Stratfield Mortimer Parish Council

Full Council 10/10/2024

Foudry Brook

INITIAL THOUGHTS ON THE FIRST RESPONSE TO THE REVIEW

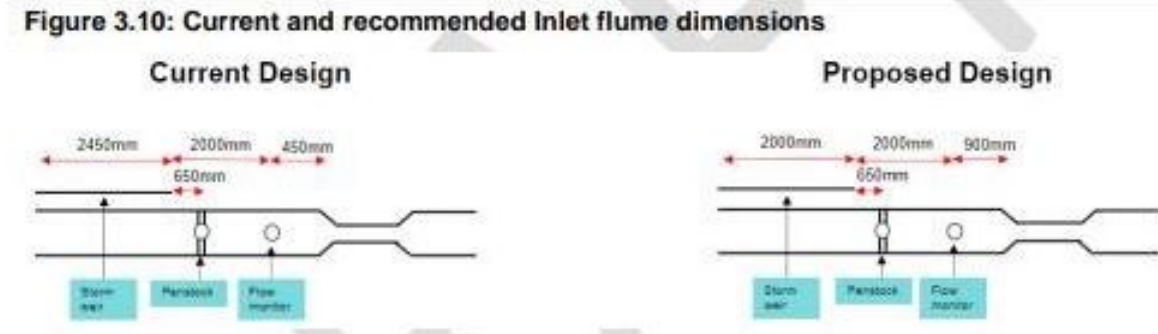
6. They do not have a diagram of the present configuration. Seems strange but one is being drawn up along with another showing the improvements. Need to get these from Paul Hampton when completed.
7. This refers to returns made to the Environment Agency each year. It appears that the current work follows a review of the system is due to be completed October/November 2024.
